Docket No. 52-002

PROJECT: CE System 80+

SUBJECT: PUBLIC MEETING OF DECEMBER 2 and 3, 1992, TO DISCUSS THE CE
SYSTEM 80+ SEVERE ACCIDENT SUBMITTAL

Figure 3.1-3: Comparison of Fragility Curves for System 80+

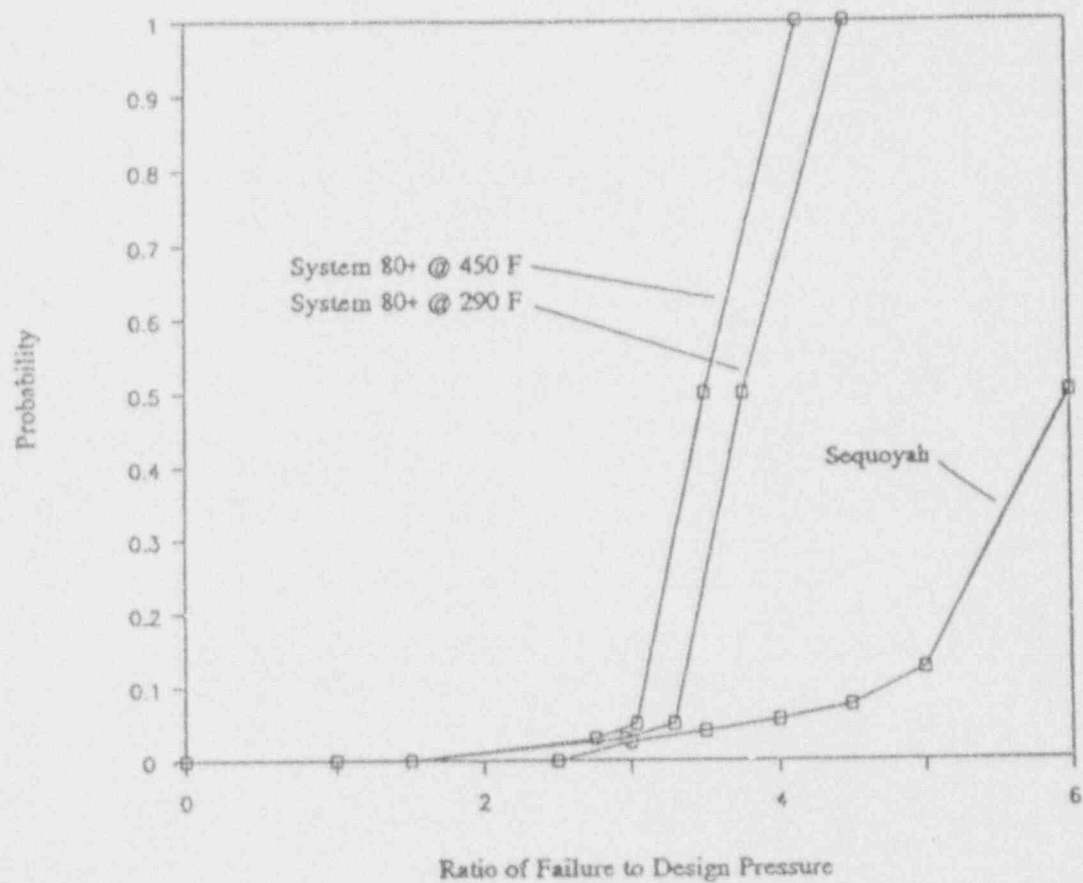
1. The statements under the item "Design Basis Pressure Capacity" section in page 3-3 of Reference 1 should be revised in accordance with the responses of RAIs 220.45 through 220.48 and 270.44.

2. From the Response to RAI 270.42 for general membrane stress for 3-D finite element model for the steel containment vessel with openings, the maximum stress intensity calculated for the testing load condition (load combination is $D + L + P_s + T_s$) at 53 psig is 24,614 psi and the allowable stress intensity for Level C Service Limit is 52,480 psi at design basis accident temperature of 290 °F. Since the stresses are at or below yield, a linear calculation for the allowable Level C Service Limit pressure can be determined as a check from the testing load condition as follows; $24,614 : 53 = 52,480 : X$, $X = 113$ psig for 3-D model. The temperature is assumed to be 290°F. From Figure 3.1-2 of Reference 1 for 2-D axisymmetric thin shell model, the Level C Service Limit pressure is 145 psig. Since the internal pressure is dominant in the resulting stresses, the difference in the results (145 psig vs. 113 psig) needs to be explained.

3. In page 3-5 of Reference 1, it states, "The material properties were represented by a bilinear stress-strain curve which was assumed to be essentially elastic-perfectly plastic in nature." which means the stress is maintained at yield, while the strain is increased. However, use is made of a 5% strain hardening modulus in SA-537 Class 2 Stress-Strain Curve (Ref. 2). Provide the reasons why a bilinear stress-strain curve with a 5% strain hardening is chosen.

PRELIMINARY RESPONSE TO ITEM 1/2/3:

The fragility curve is developed from shell membrane stress-strain curves based on structural analyses performed by DESI and information from NUREG-1150 (SAND-1309) "Experts Determination of Structural Response Issues", Issues 5 and 6.

1. Experiments show that general failure of steel containments will not occur until a global strain of 2% has been reached.

ASME Ultimate calculation taken as a failure probability of .05 (strain = .003). Based on expert A (issue 1) and assuming the failure probability in this range is linear with strain, the failure probability for a .3% strain is between .03 and .15. A value of .05 was selected as being consistent with the Sequoyah fragility curve.

Median failure point conservatively selected based on Sequoyah fragility curve and expert judgement as 0.5% strain.

System 80+ Cavity Flood System Cavity Height vs. Time

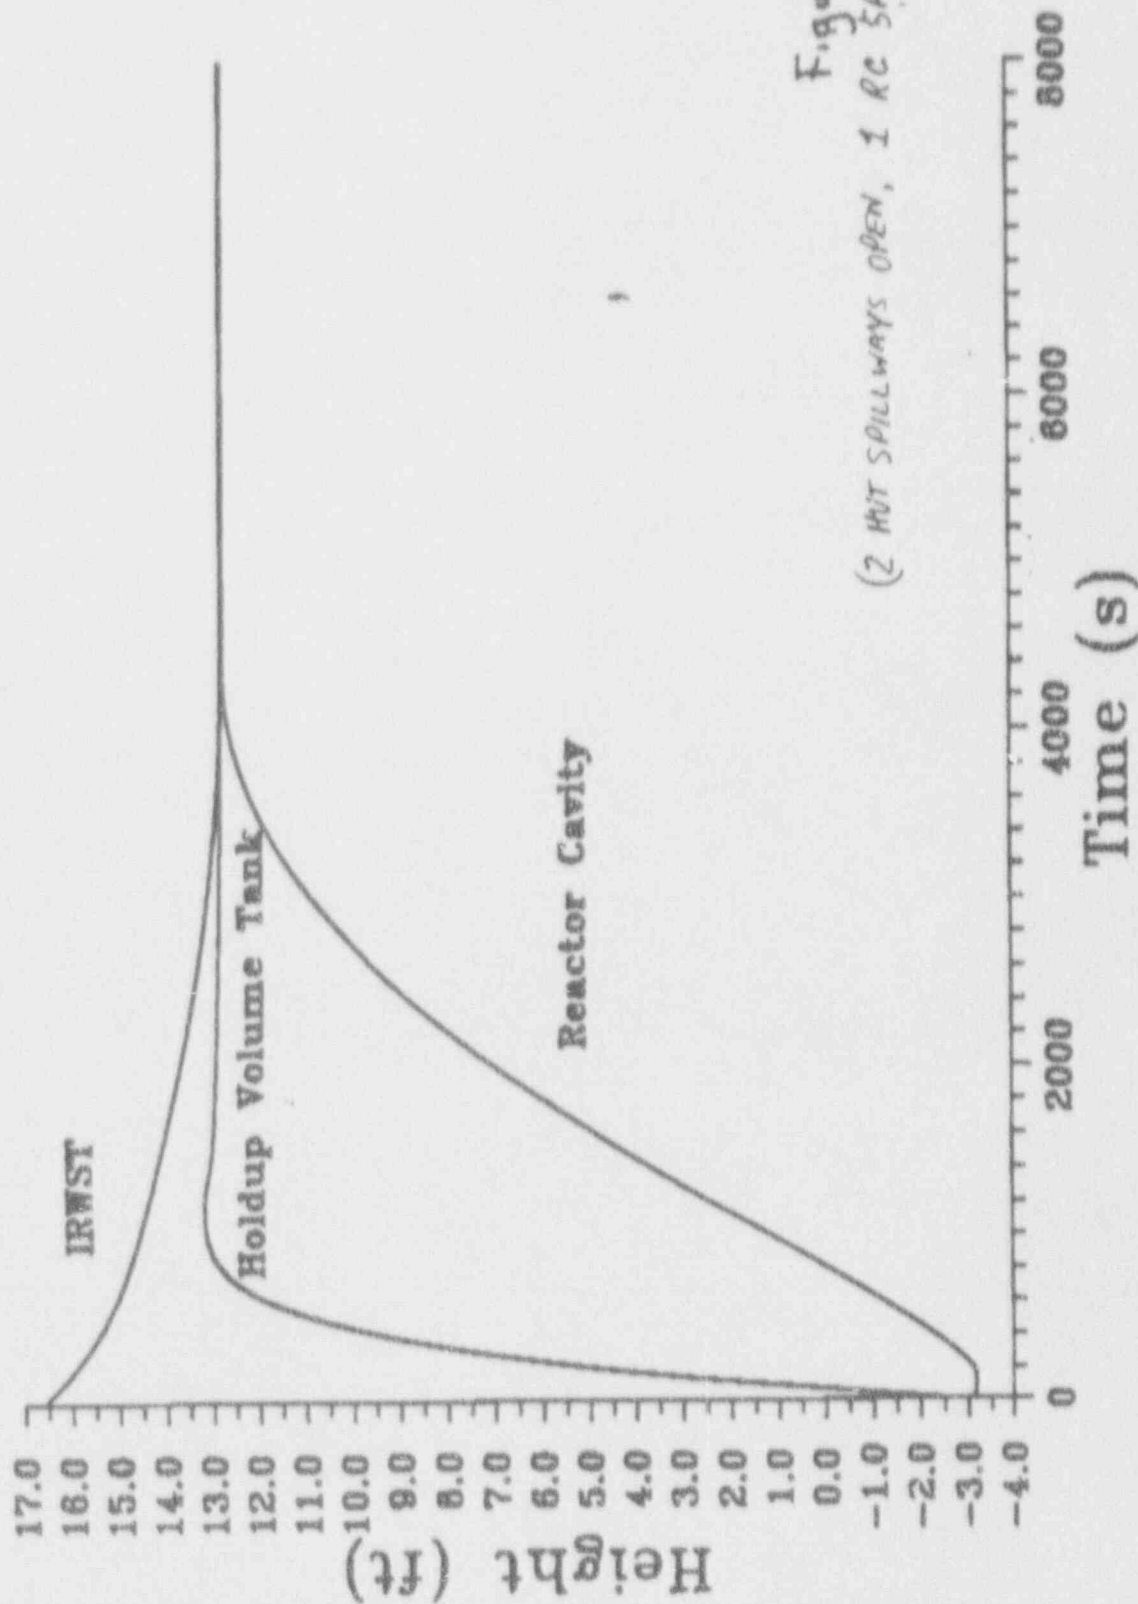
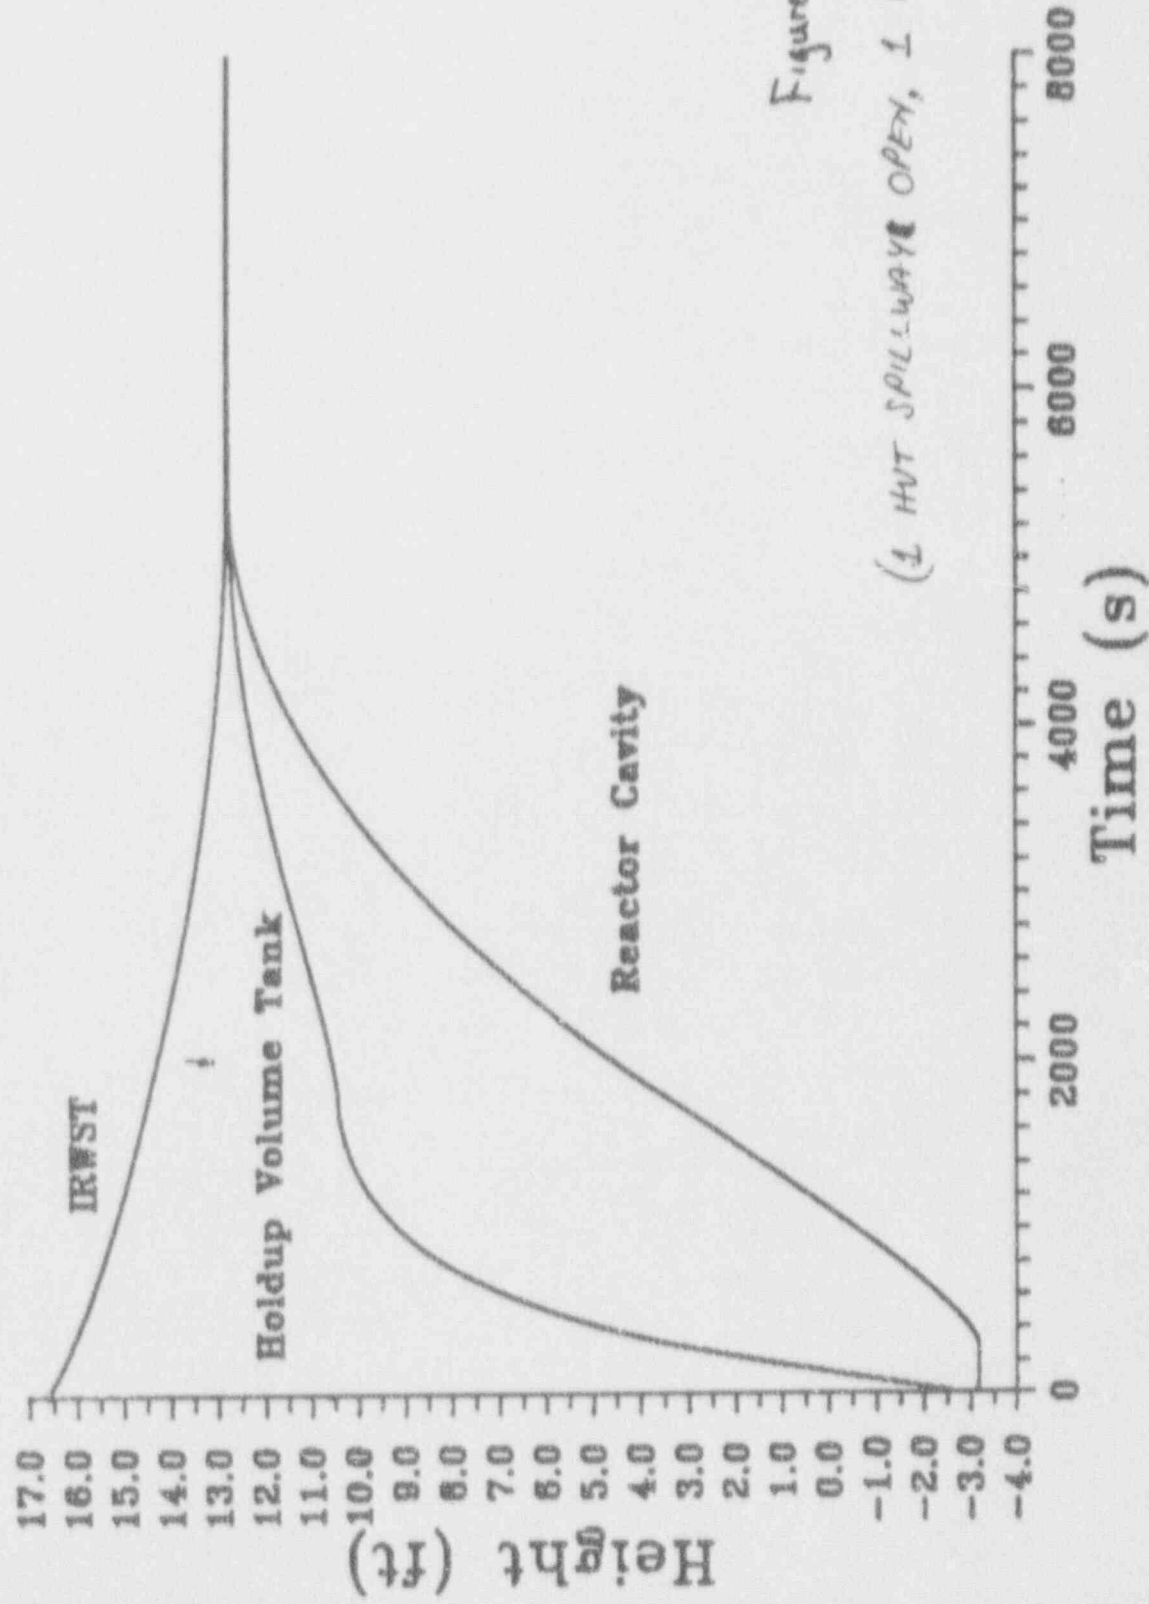
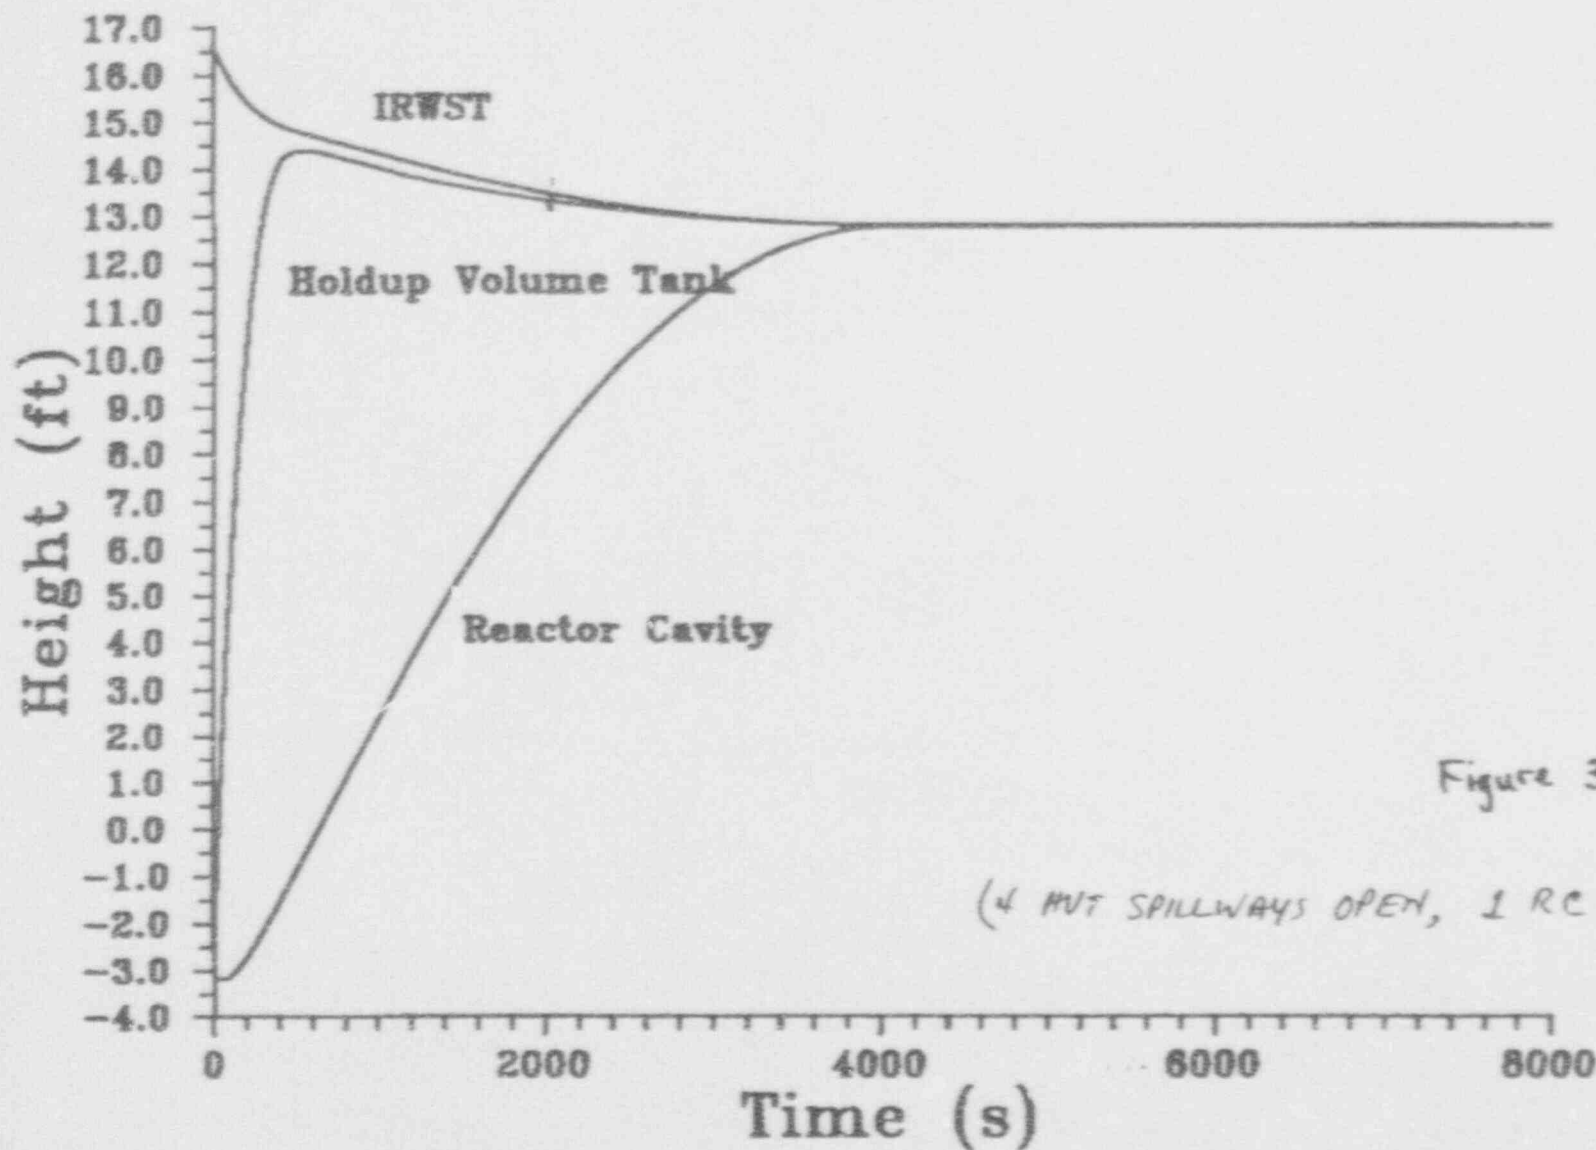
9. 3-13 What is the purpose of the holdup volume tank? Why not flood directly from IRWST to reactor cavity?
10. 3-15 Provide timing for filling the HVT, reactor cavity, and final level in each. Do any accident sequences result in a core mass in dry cavity or only partially filled cavity?

PRELIMINARY RESPONSE TO ITEMS 9,10 AND 11

Figure 4-28. Westinghouse instrument guide tube failure map at maximum radial gap (0.008 cm).

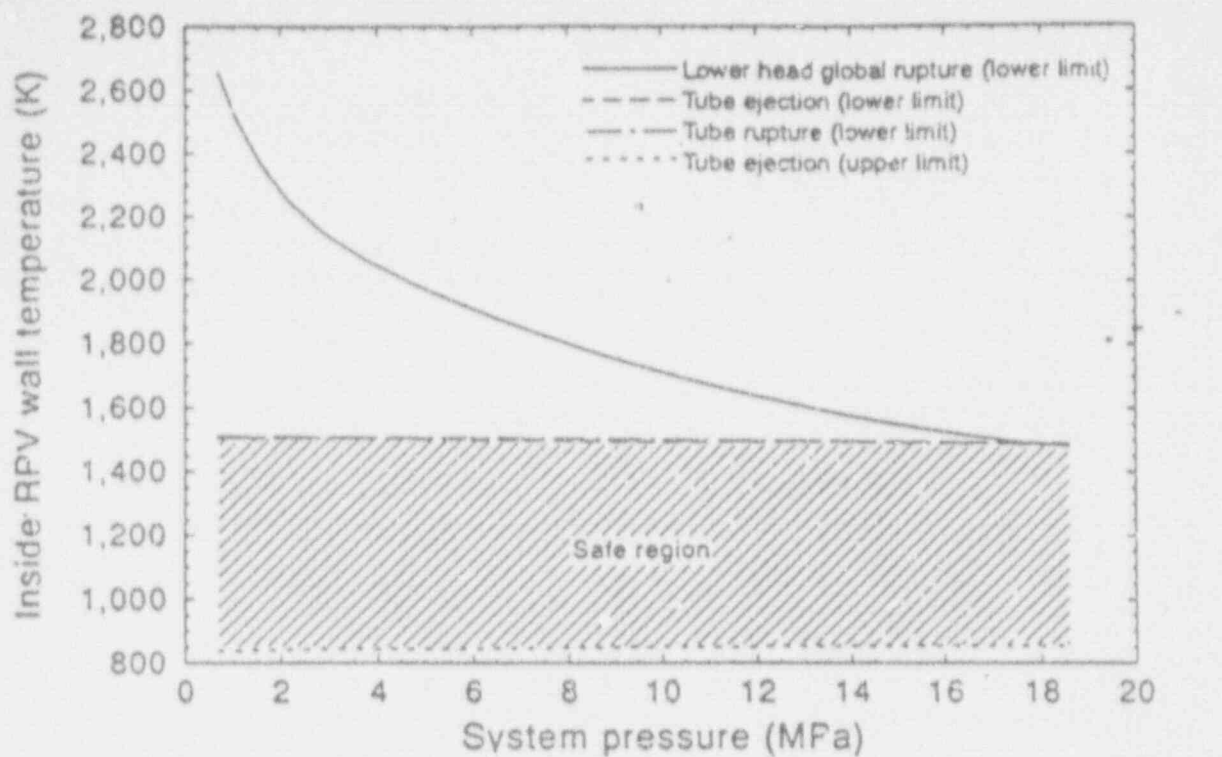
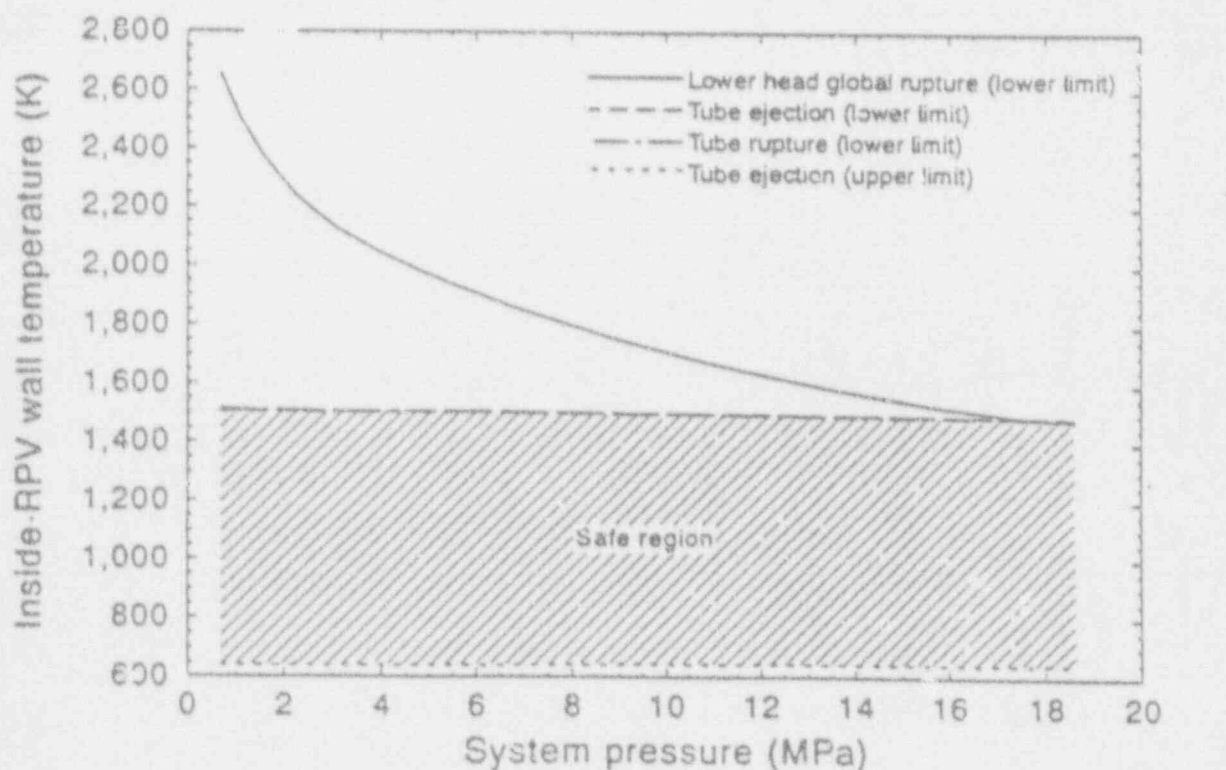
- (7) ABB-CE committed to document their conclusion that the most probable mode of reactor vessel failure is via the instrument tubes.
- (8) ABB-CE committed to provide the hand calculation that determines the maximum pressure spike resulting from adiabatic, isochronic complete combustion (AICC) of hydrogen.

PRELIMINARY RESPONSE TO ITEM 43

The RV lower head failure map of NUREG/CR-5642 demonstrates that the most likely mode of RV failure will be caused by either instrument tube ejection or tube rupture. These maps are generally applicable to the System 80+ lower head. See attached sheet.
